PROPOSED IMPROVEMENT
BRIDGE PROJECT
TOWN OF BERKSHIRE
COUNTY OF FRANKLIN
VT. ROUTE 118 - MAJOR COLLECTOR
BRIDGE NO. 30

RECORD PLANS

PROJECT NAME:	BERKSHIRE		
PROJECT NUMBER:	BHF 0283(9)S		
FILE NAME:	SC304IND2.XLS	PLOT DATE:	4/2/09
PROJECT LEADER:	R. HEBERT	DRAWN BY:	S. MORGAN
DESIGNED BY:	R. HEBERT	CHECKED BY:	R. HEBERT
INDEX OF SHEETS	SHEET 2	OF	41

FRT VIEW
P1 - P4
P22 - P25

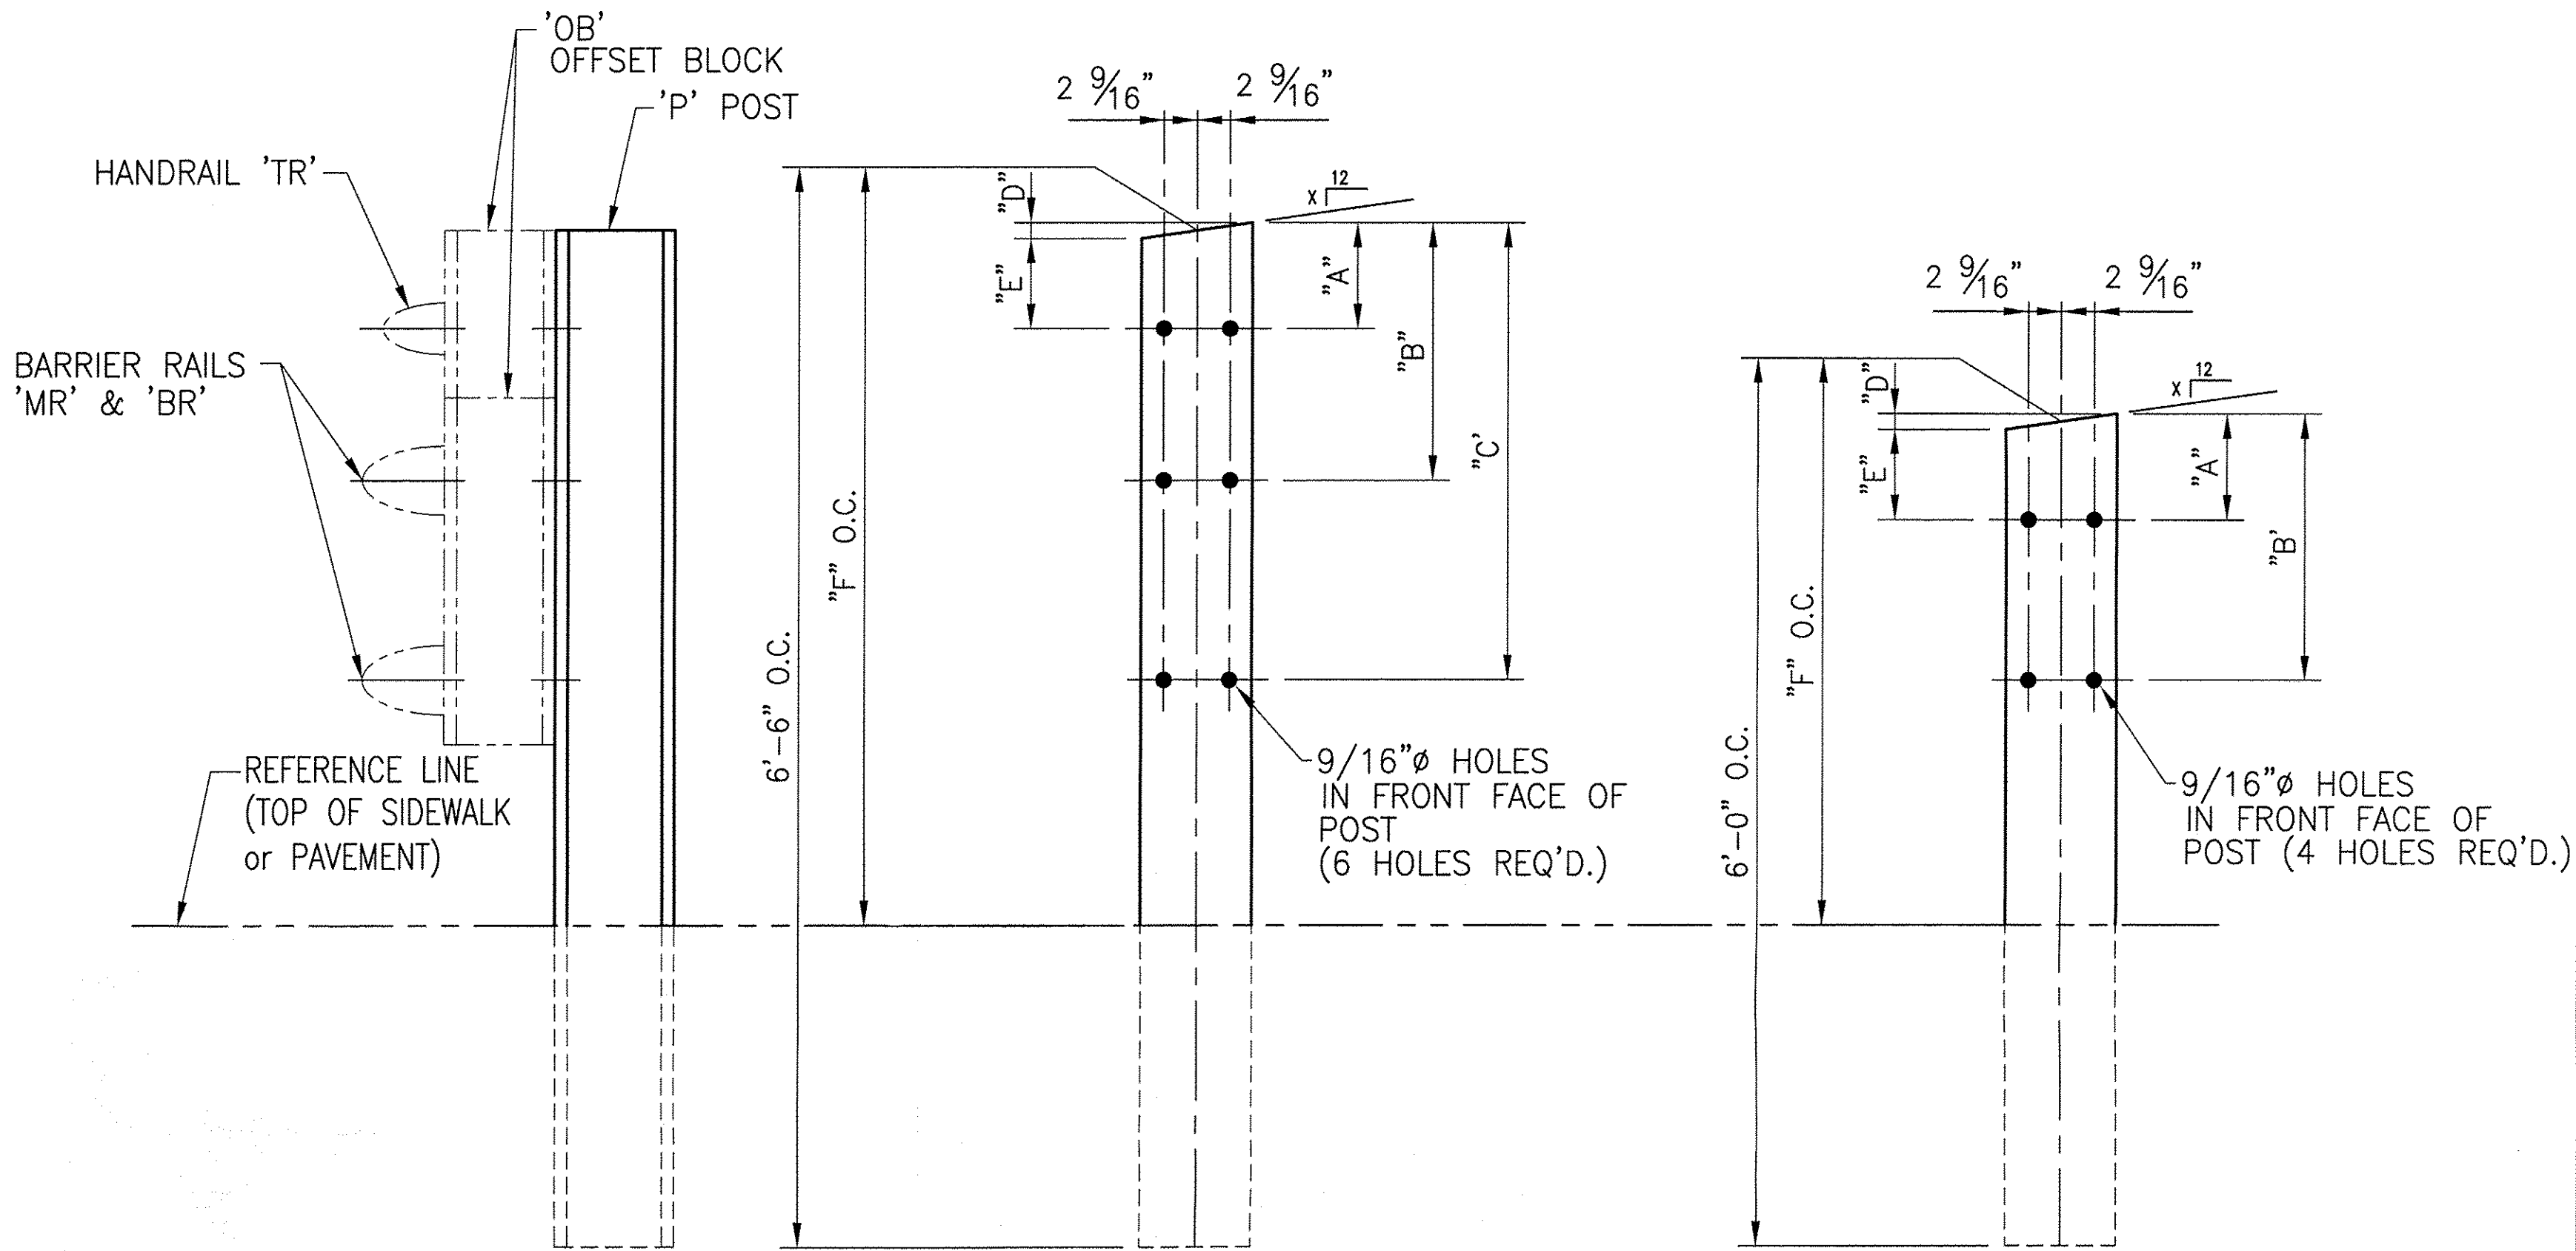
REVISED DIMENSIONS PER APPROVERS MARKUPS	CMS	03 23 10
REV.	DESCRIPTION	BY	DATE

P12 - P14
P19 - P21

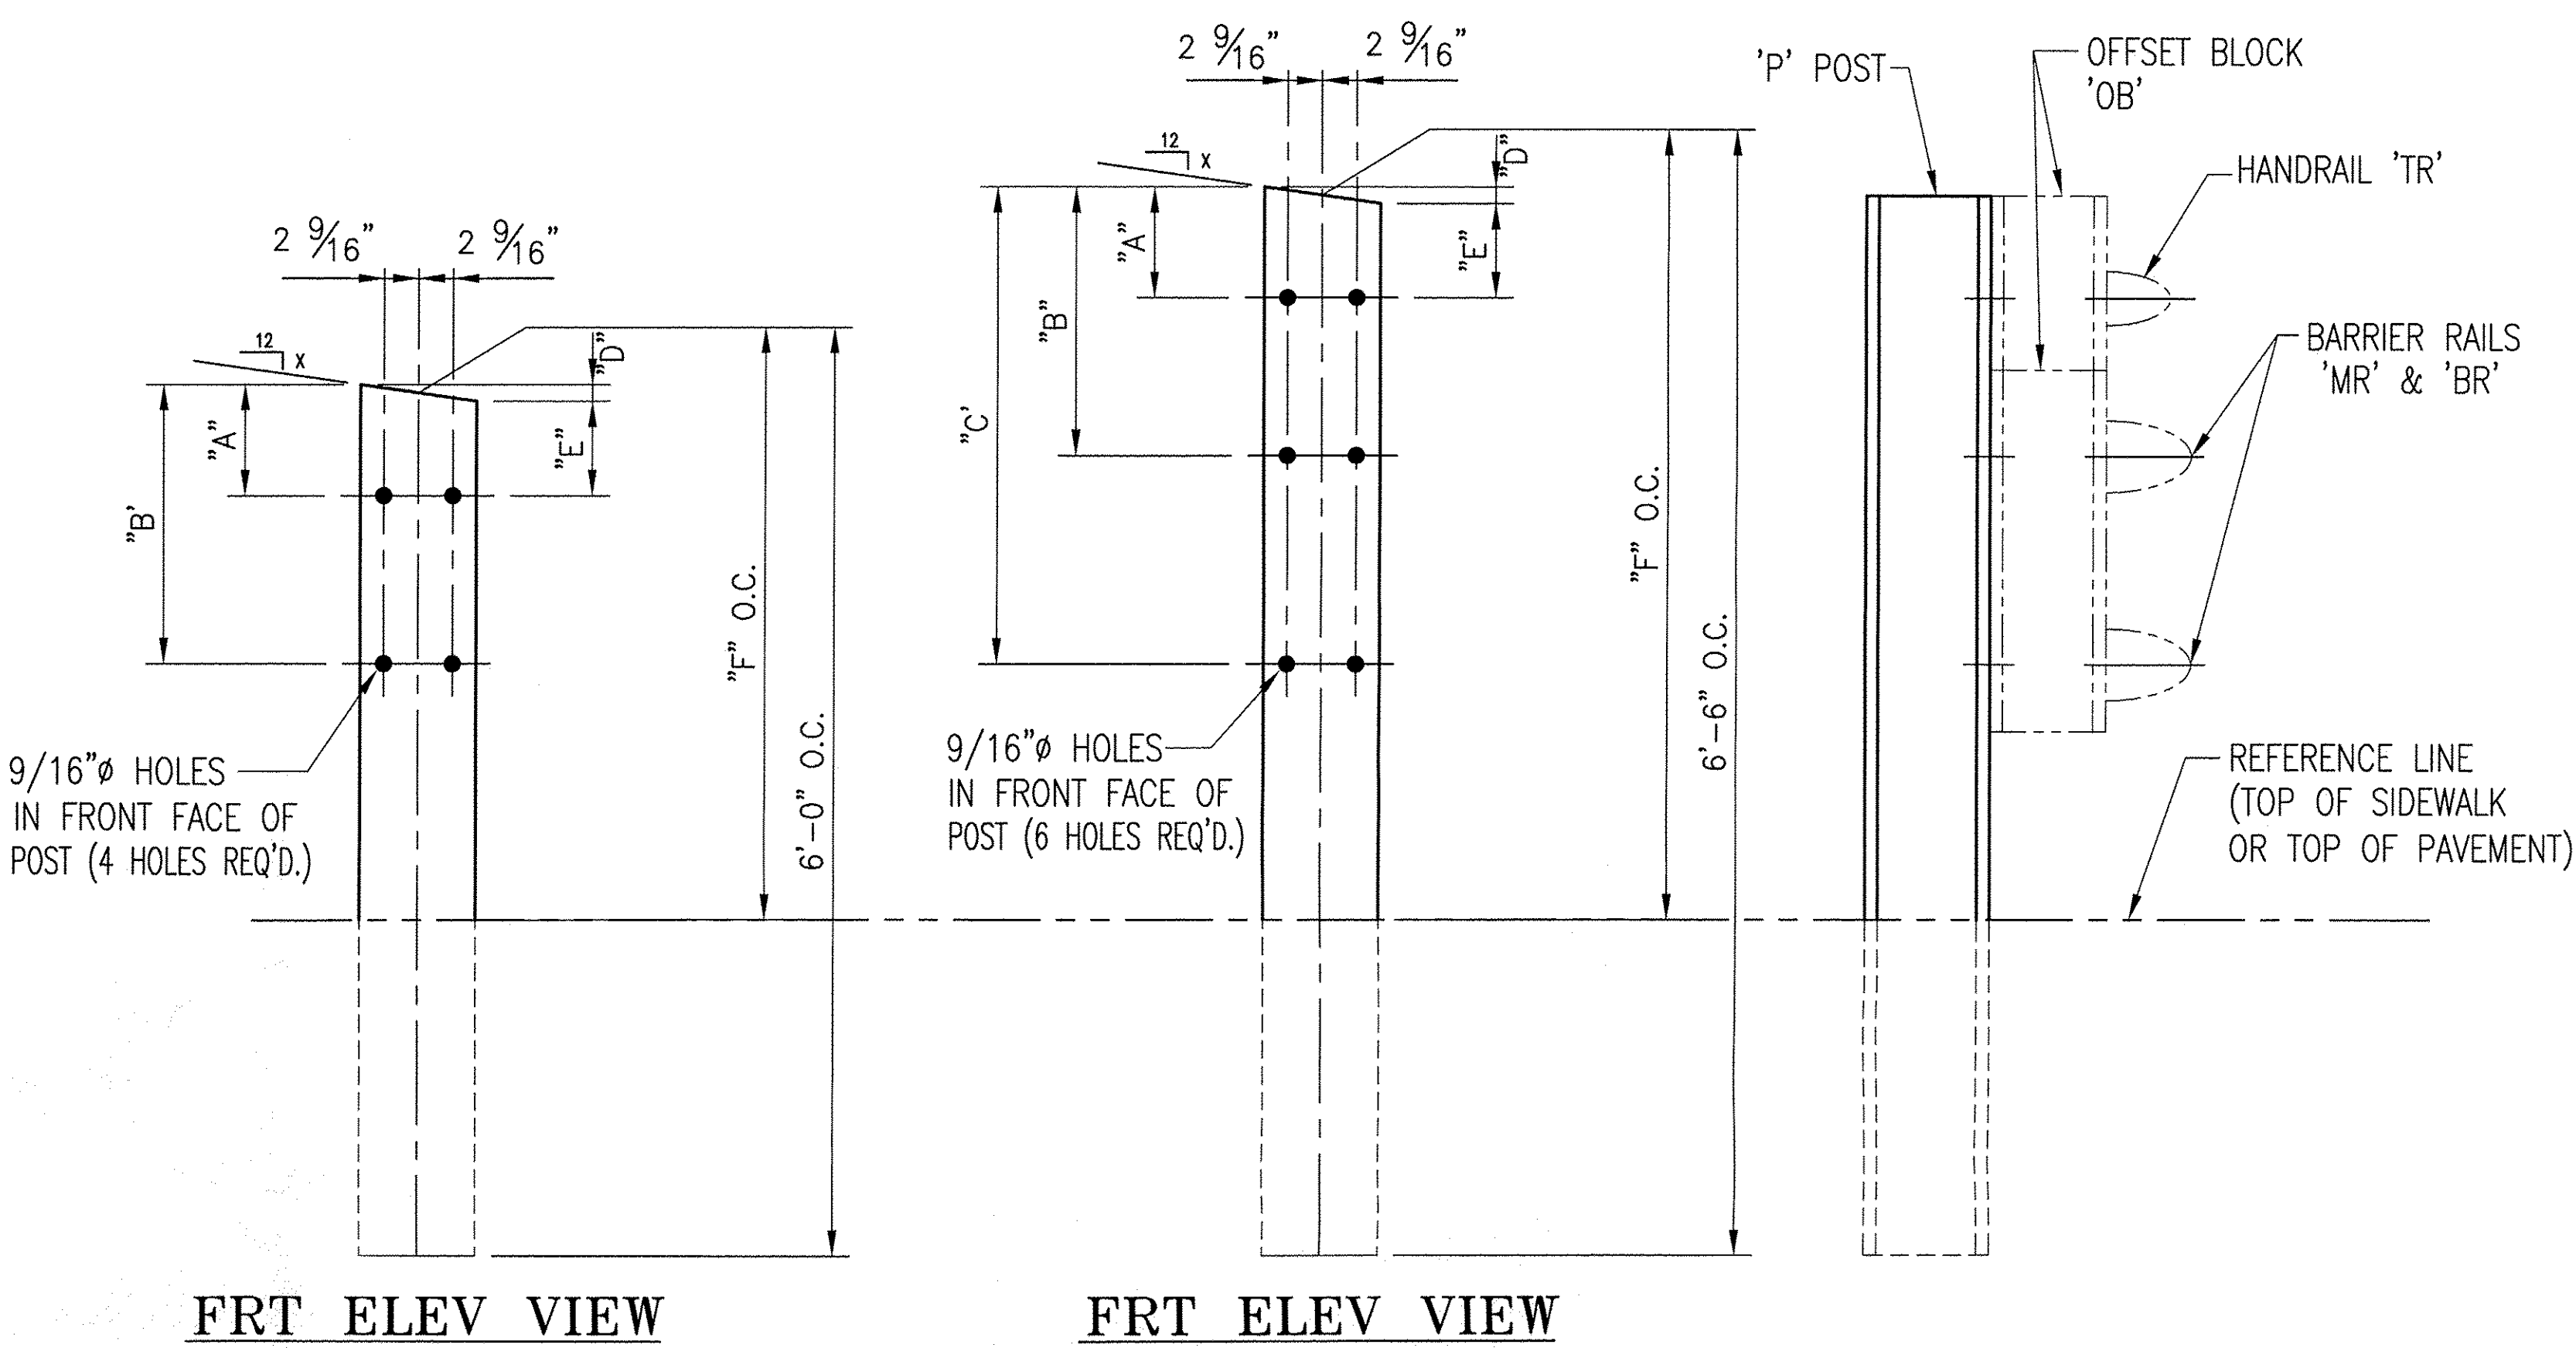
REVISED DIMENSIONS PER APPROVERS MARKUPS	CMS	03 23 10
REV.	DESCRIPTION	BY	DATE
